SUBJECT: Forwards draft proposed FSAR changes, including revs to steam
 supply logic & recirculation flow path for auxiliary
 feedwater sys to correct nuclear cooling water sys
 flowrates.Changes will be incorporated in FSAR Amend 14. *56.6 rpt*

Enclosed for your information are draft proposed FSAR changes. These changes 1) identify the presence of essential HVAC to cool the essential spray pond pumphouse, 2) revise the steam supply logic and recirculation flow path for the auxiliary feedwater system (Reference 1 and 2), 3) correct nuclear cooling water system flowrates, 4) clarifies the closure time of the main steam stop valves, 5) update the listing of safe shutdown equipment in accordance with the spurious actuation analysis submitted in Reference 3, 6) delete the letdown line low flow alarm, and make editorial corrections and clarifications. These changes are considered acceptable as 1) the essential HVAC meets design criteria as described in section 3.2, 2) the auxiliary feedwater system changes are consistent with CESSAR safety analyses, 3) the nuclear cooling water flowrates meet design requirements, 4) the revised closure time of the stop valves is consistent with the man

PVNGS
FSAR
BLOCK DIAGRAM
AREA/UNIT EVACUATION SYSTEM
FIG. 9-5-4

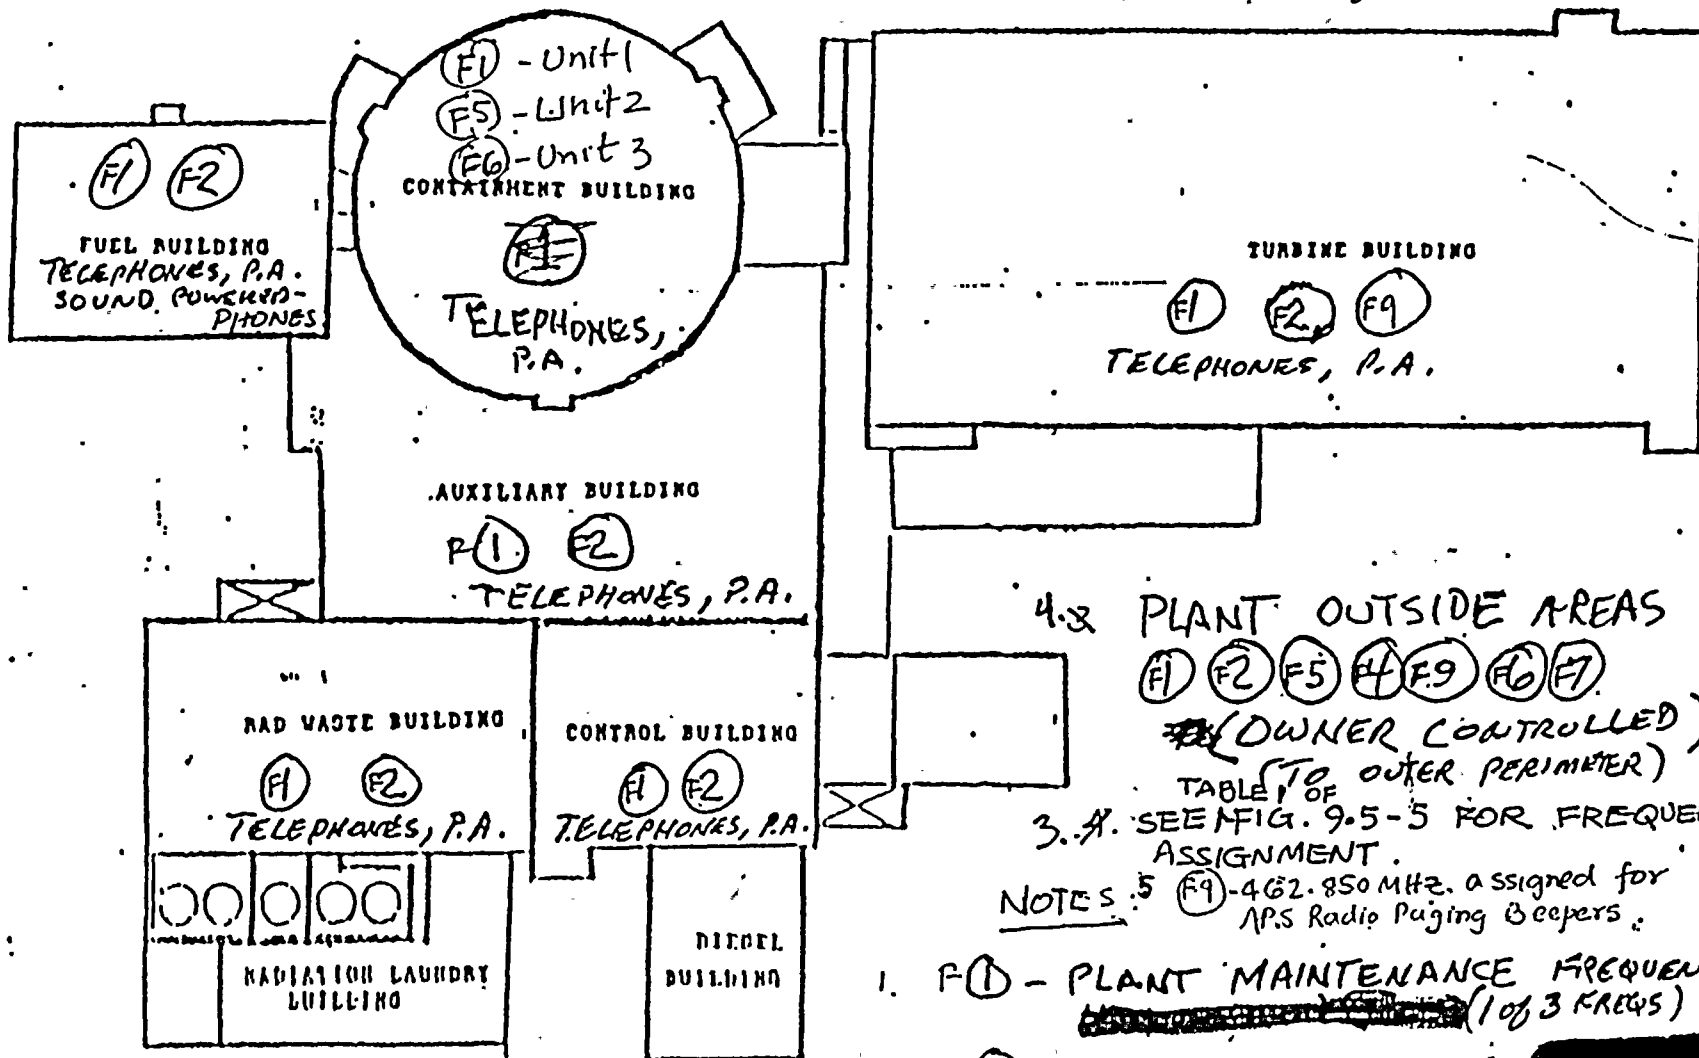
Replace existing layout with this new one.

REDLINE EVACUATION LAYOUT WITH THIS SIGN LAYOUT

Palo Verde Nuclear Generating Station FSAR
	FIRE AREAS PLANS BELOW GRADE
	Figure 9B-1

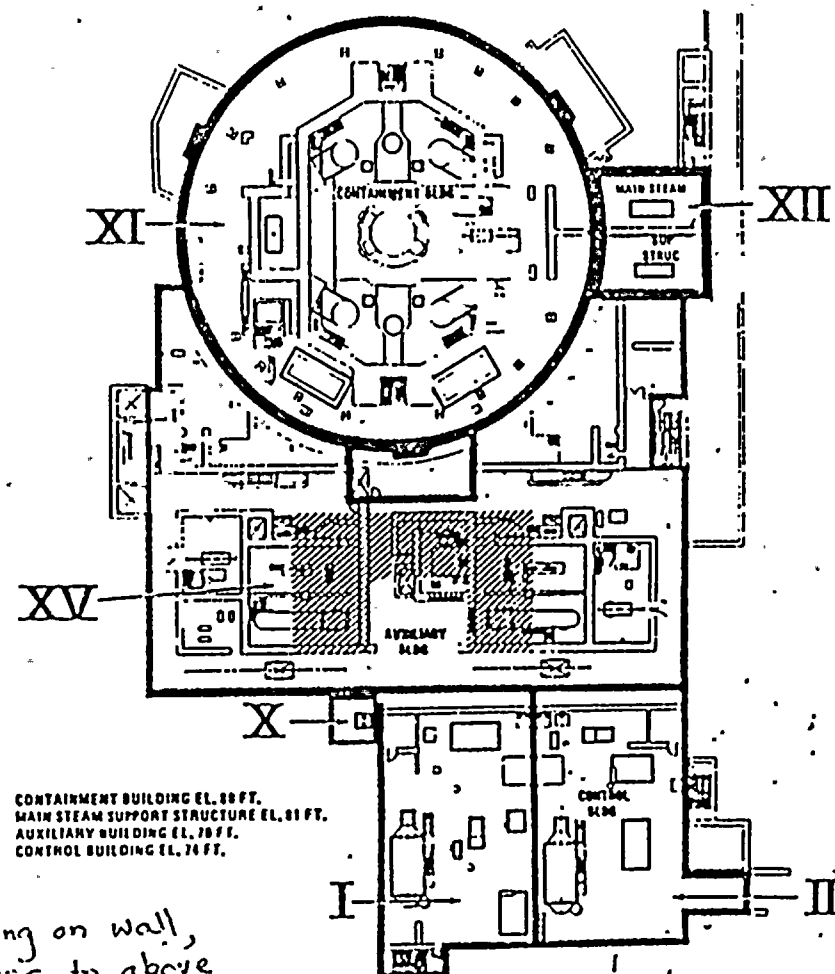
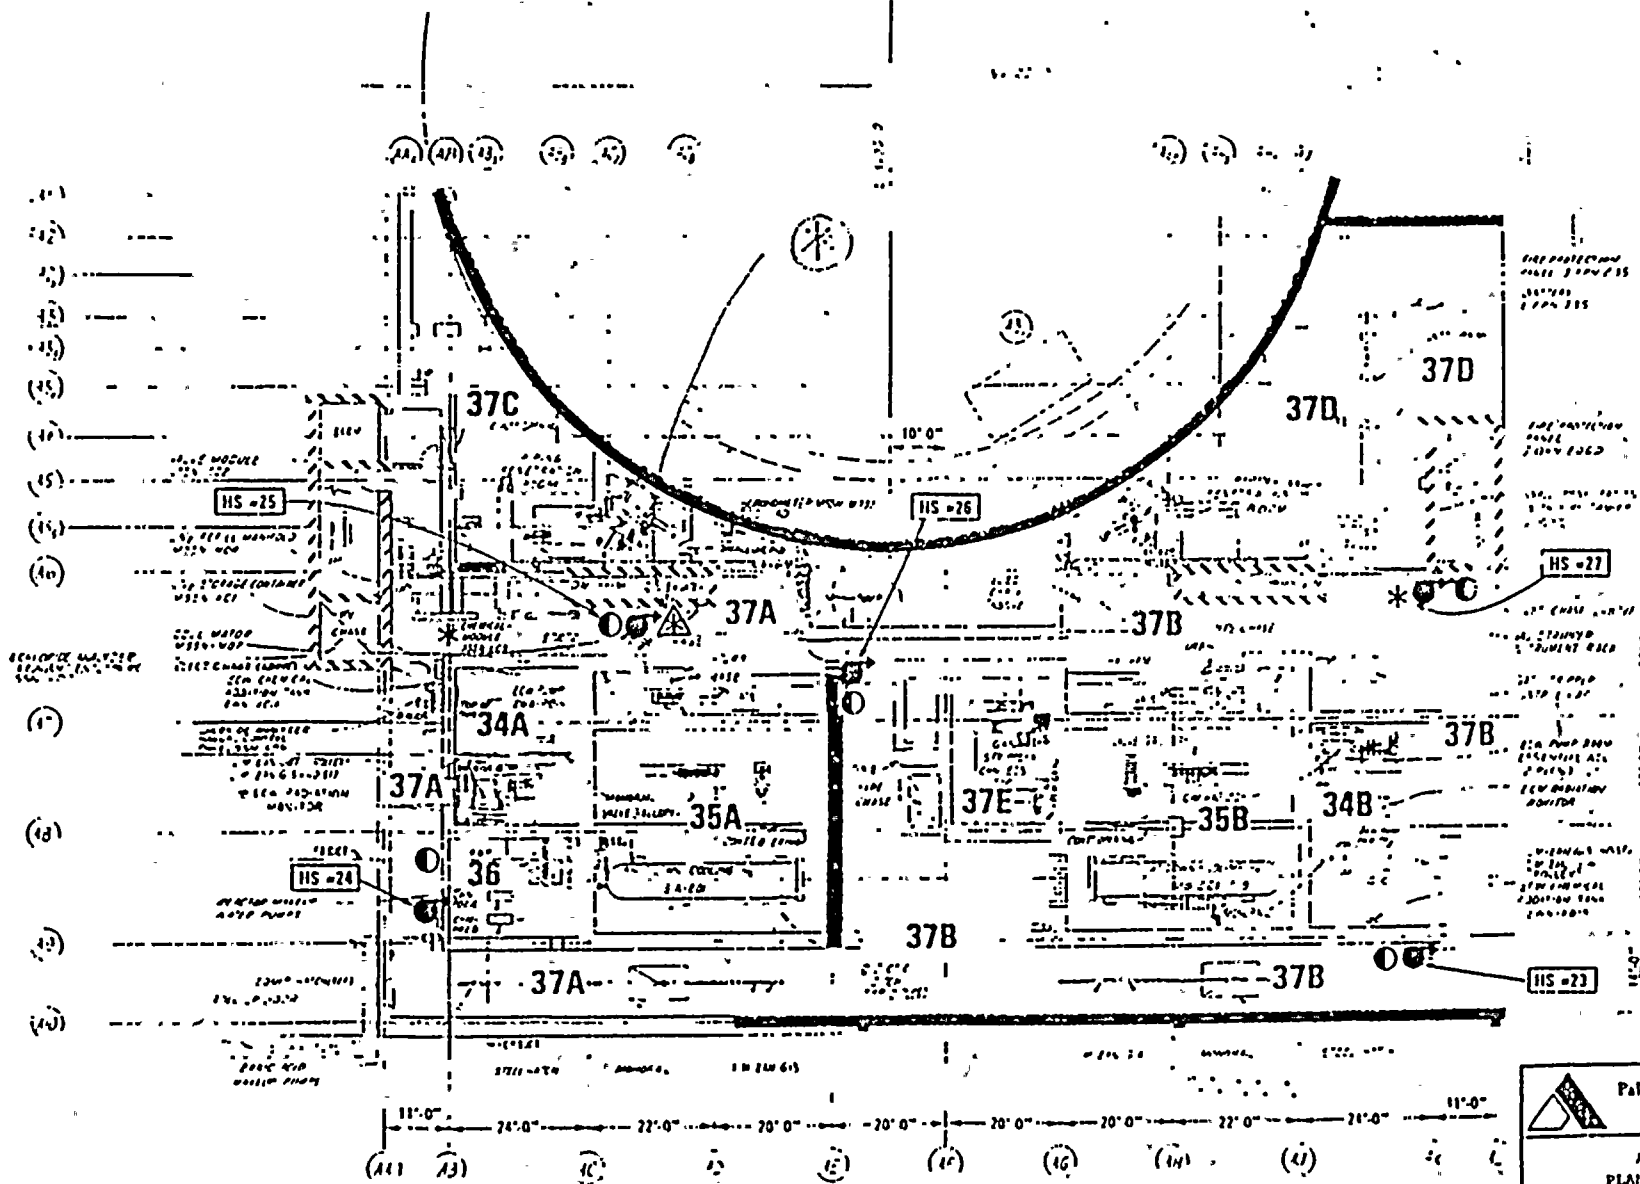
delete shading on wall,
redraw similar to above
as:

Figure 98-23

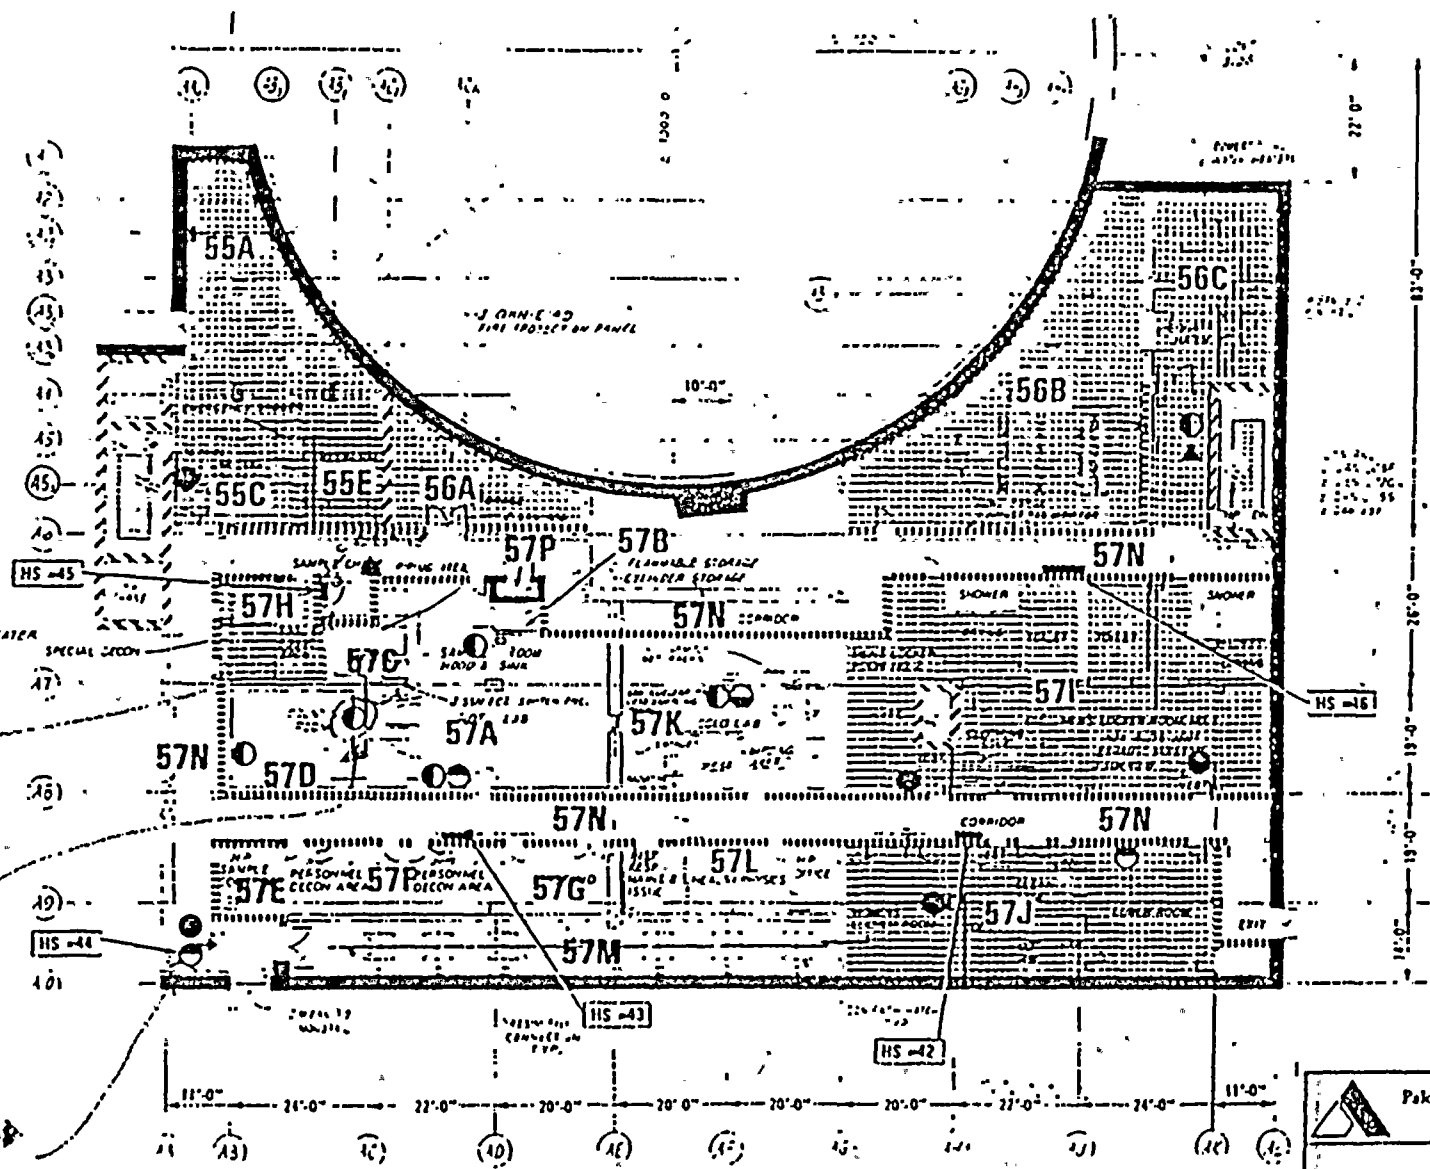
SHOW
HOLE
LENGTH
